SUMNER-BONNEY LAKE SCHOOL DISTRICT SUMNER HIGH SCHOOL ADDITION - PHASE 2 VALUE ENGINEERING REPORT SEPTEMBER 12, 2025

Revised 10/13/2025 with updated Implementation Data

This value engineering (VE) report is presented to Sumner-Bonney Lake School District and the design team to support decision making at the design development phase for the Sumner High School Addition - Phase 2 project.

Baseline Concept

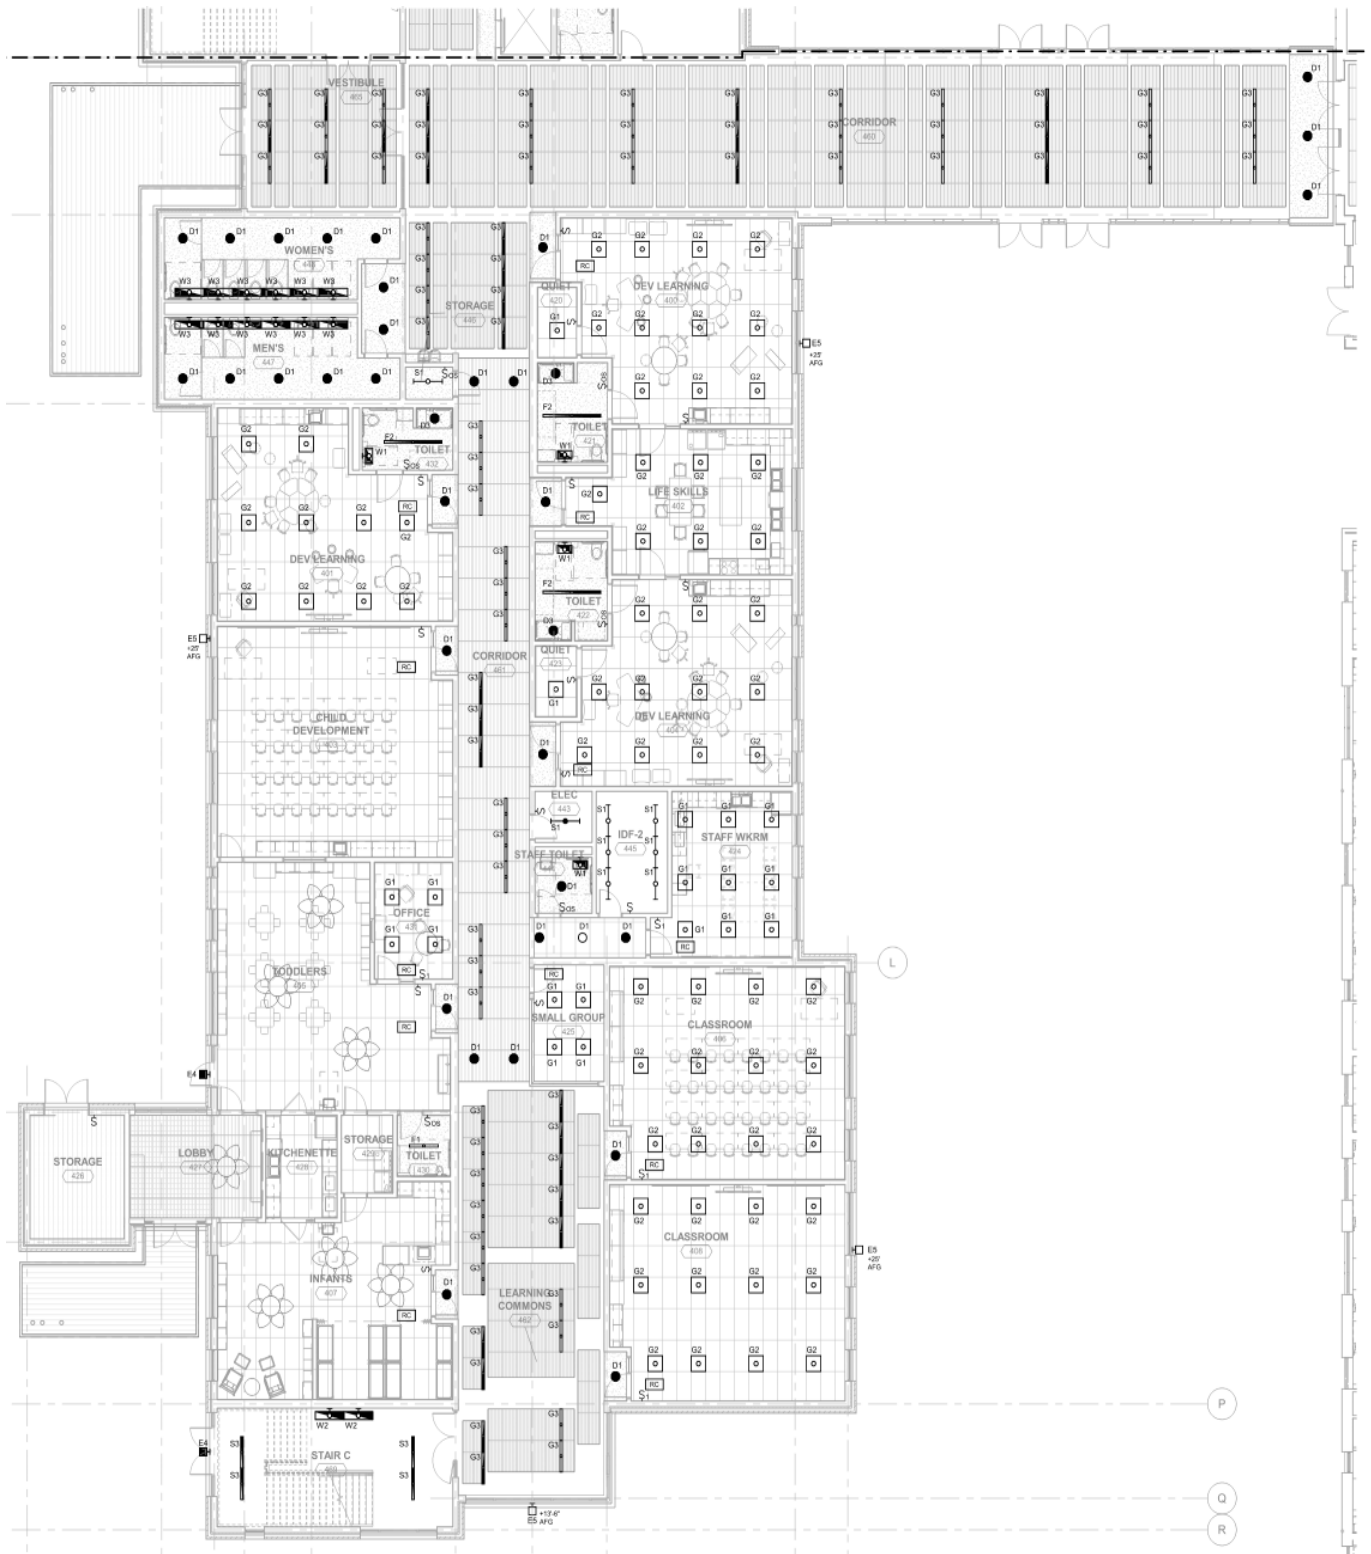
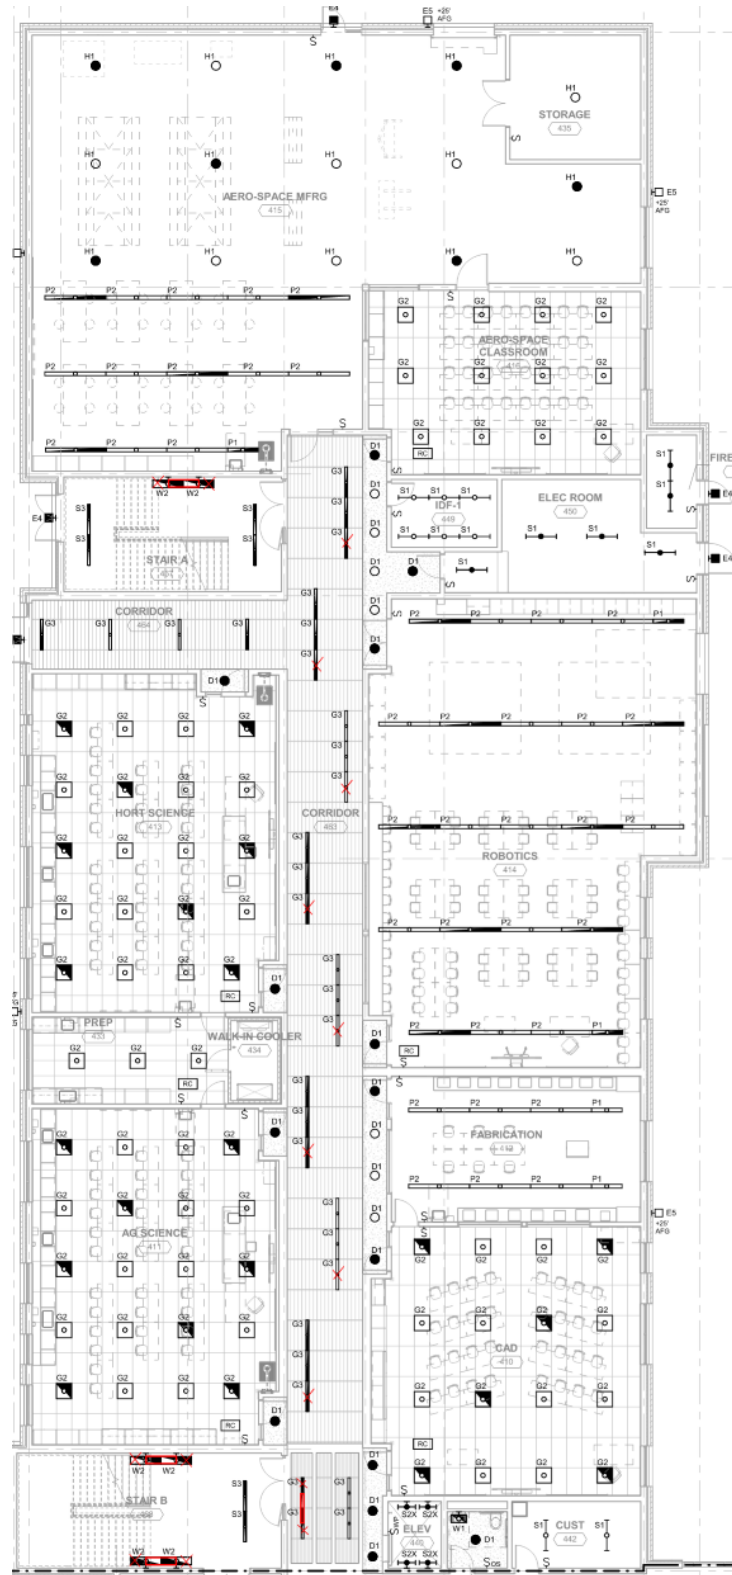
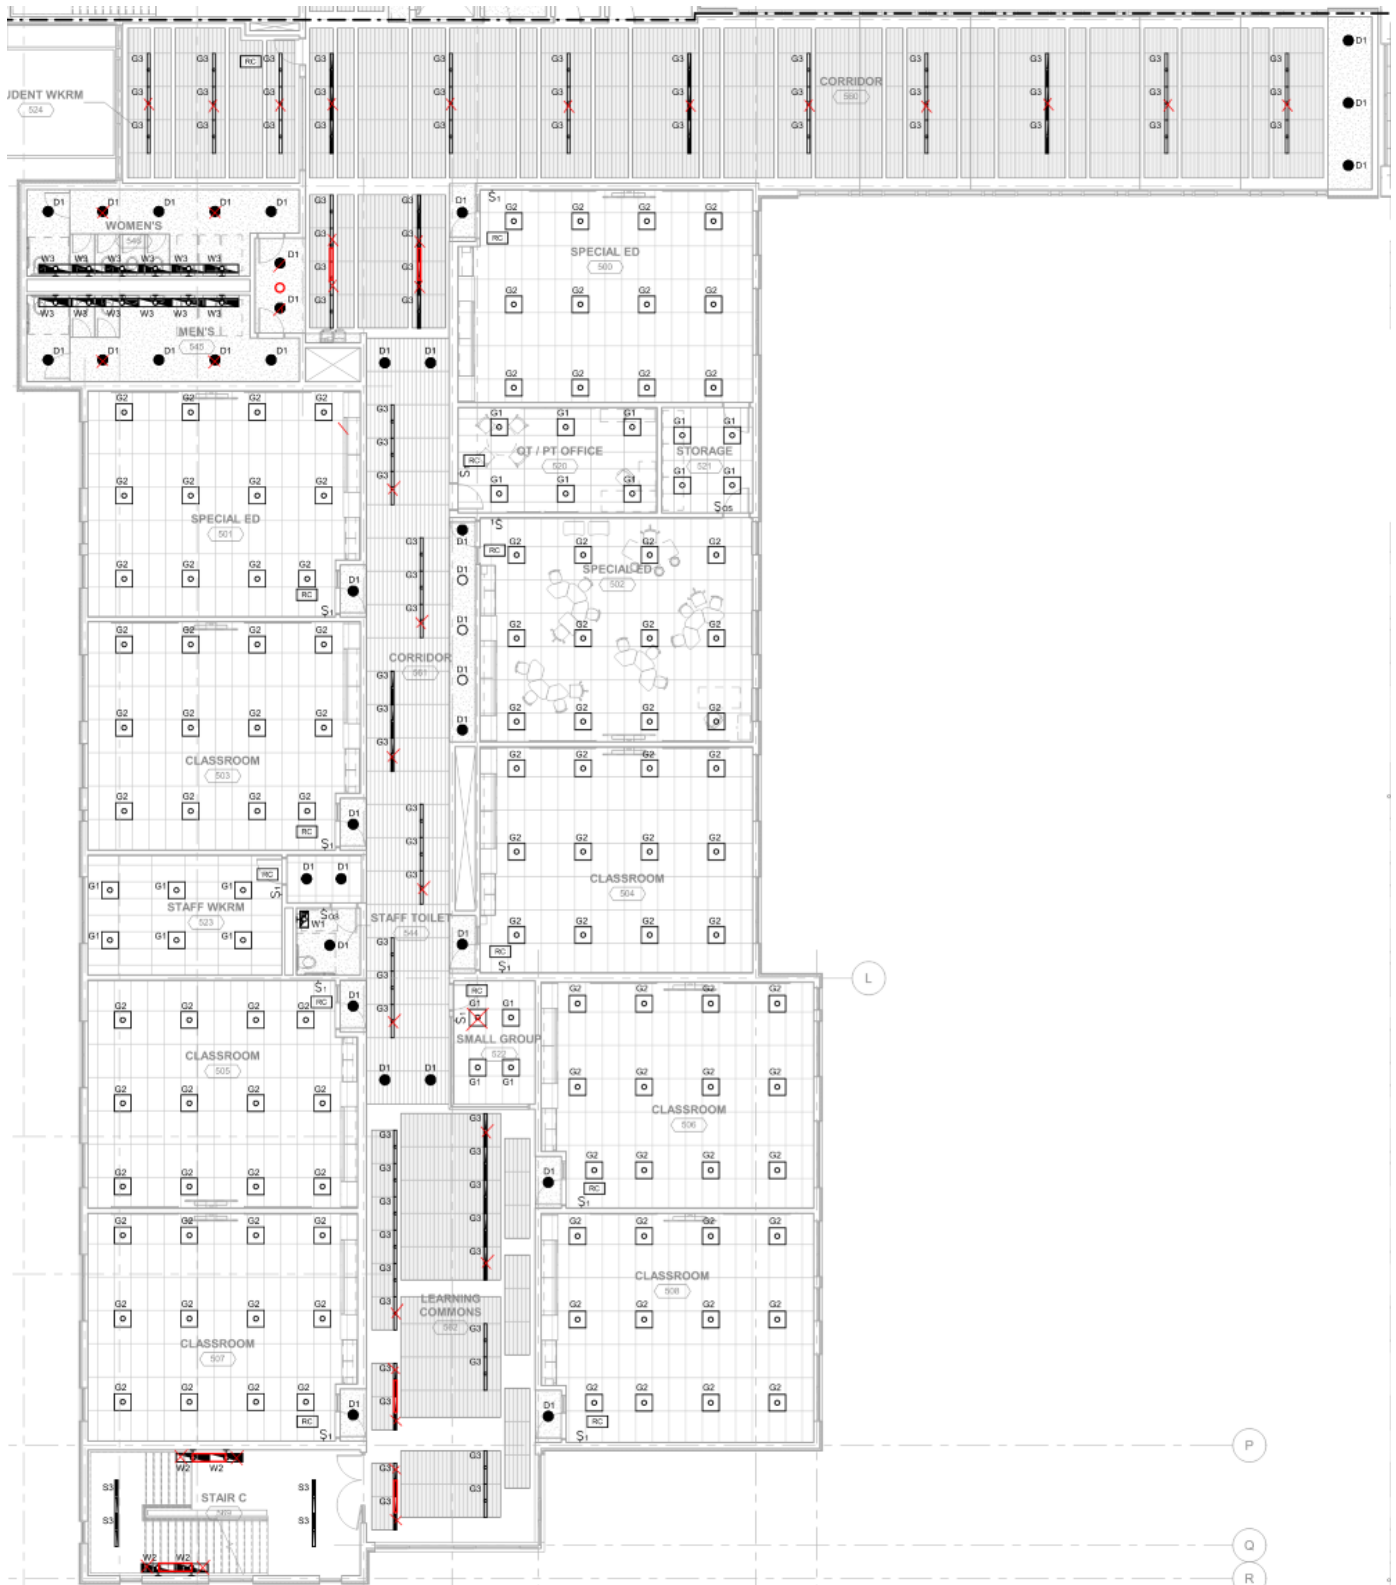
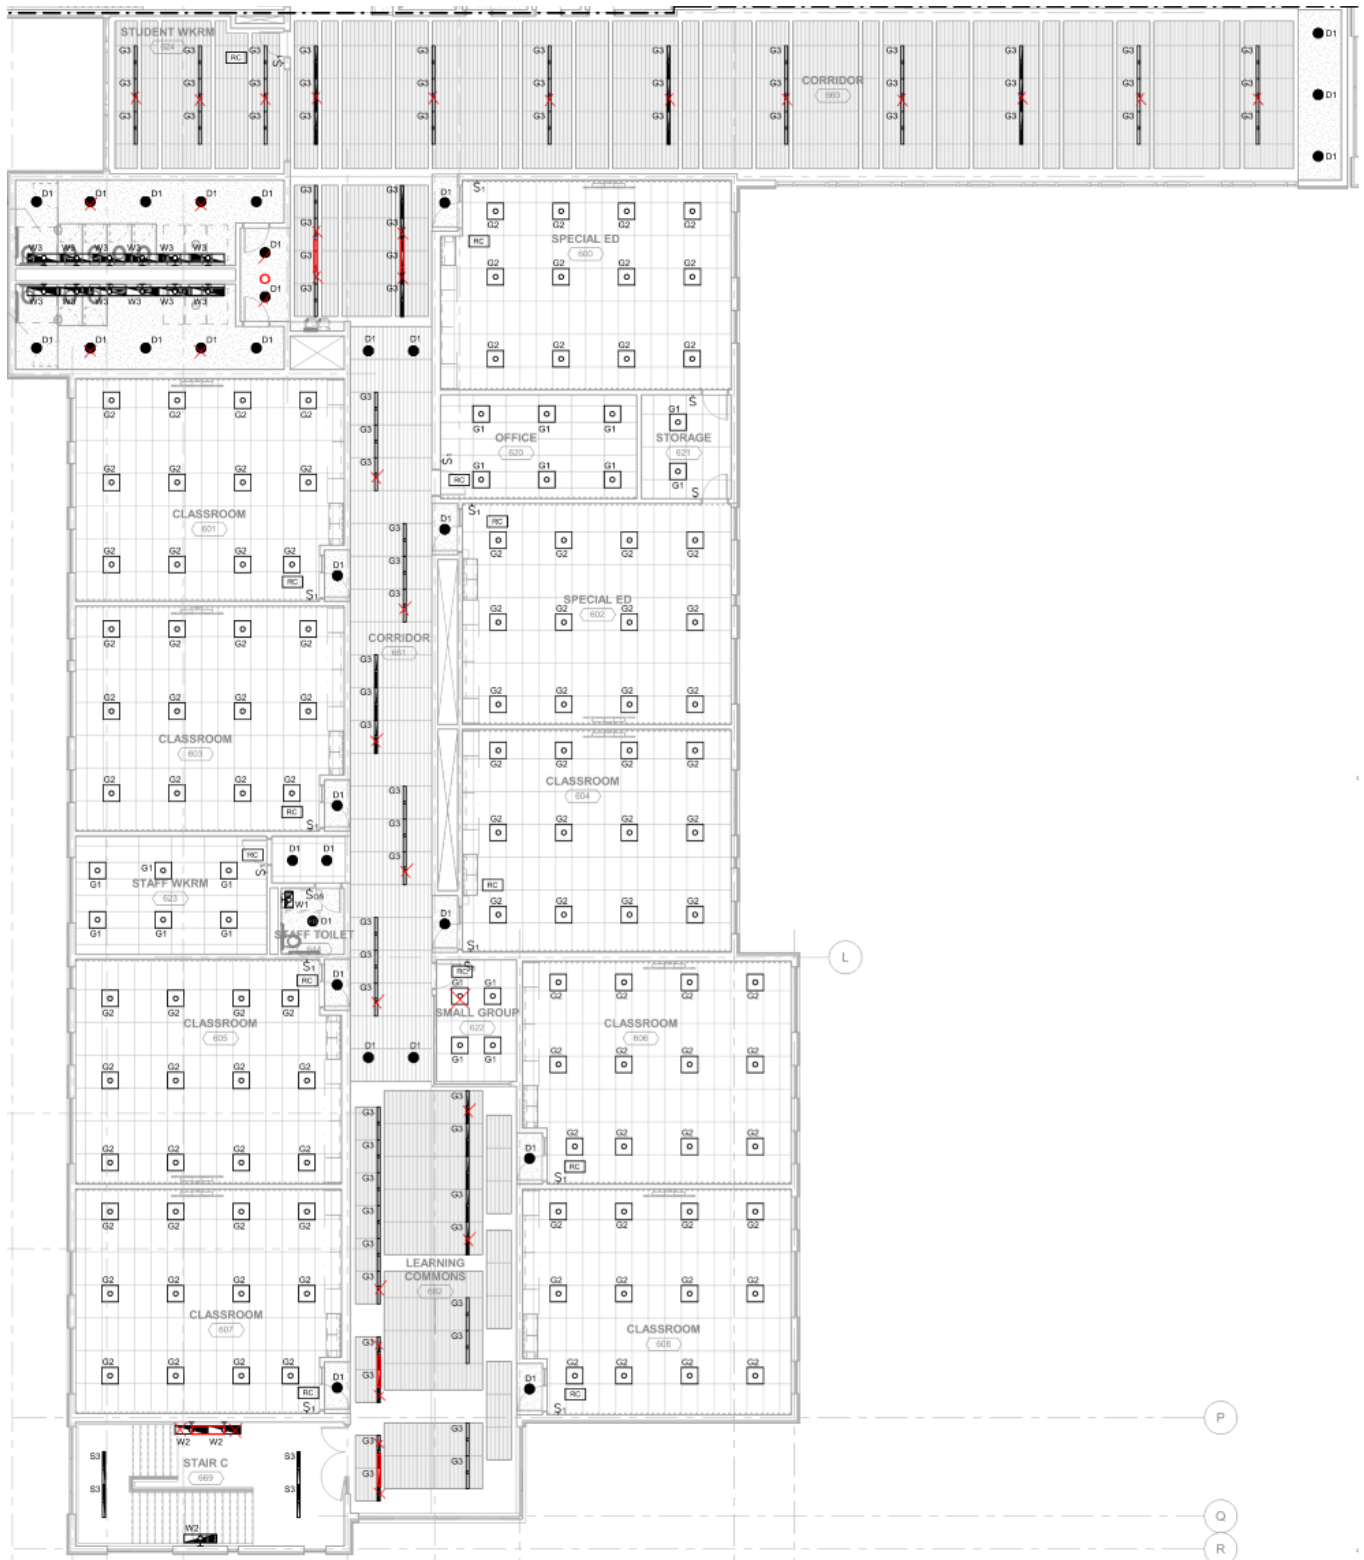
PROPOSAL	E2
COMPONENT: Lighting Density	AUTHOR	MW
BASELINE CONCEPT: The current design provides 10% lower power density than code. Light fixture layout provides design light levels and maintains even light level uniformity.		
VALUE PROPOSAL SYNOPSIS: Provide 20% lower power density than code. Light fixture layout provides slightly lower light levels and maintains even or slightly reduced light level uniformity.		
SCHEDULE SAVINGS: Improved		
QUALITATIVE BENEFITS:		
RELIABILITY	M&O	FUNCTIONALITY
Improved	Improved	Maintained
FUNCTIONS:		
Enhance Vision	Illuminate Surfaces	Illuminate Egress
ADVANTAGES: <ul style="list-style-type: none"> • Reduced Material Costs • Improves Schedule • Reduced Labor • Improved Maintenance • Life Cycle Cost Savings 		DISADVANTAGES: <ul style="list-style-type: none"> • Reduced Light Level • Reduced Lighting Uniformity • Added Supplemental Lighting.

The lighting design in classrooms will be unchanged. The proposed lighting design in other spaces and corridors will result in an additional 10% reduction in lighting power density. The effect on lighting will be slightly lower light levels and slightly less lighting uniformity.

E2	Lighting Density	151,000		X		0	Hargis Response: Reducing fixture quantity does not inherently mean 20% LPD reduction is achievable as the fixtures lumens and wattages are being prescriptively selected through photometric calculation. The suggested deletions particularly in the stairwells will make it nominal from a lighting level standpoint and make the PH2 stairs different than PH1 stairs. We do not suggest accepting this item.
R1	Use pavers ILO concrete in courtyards (assume 50%)	(280,460)		X		0	Fora Response: High quality pavers would add significant cost, however paving interest will be improved through creative placement of joints and use of surface retarder at select locations.
R2	Raise concrete crosswalks to slow traffic and improve safety	(17,100)		X		0	JCE Response: REJECT - Discussed with School District and architect, we will add speed bumps in-lieu of raised concrete to slow incoming traffic. Fora Response: Raised crosswalk would conflict with grading/drainage of parking lot, District has expressed interest in speed bumps with more limited cost impact - Fora will work with civil to locate these while minimizing impact to grading/drainging of parking lot.
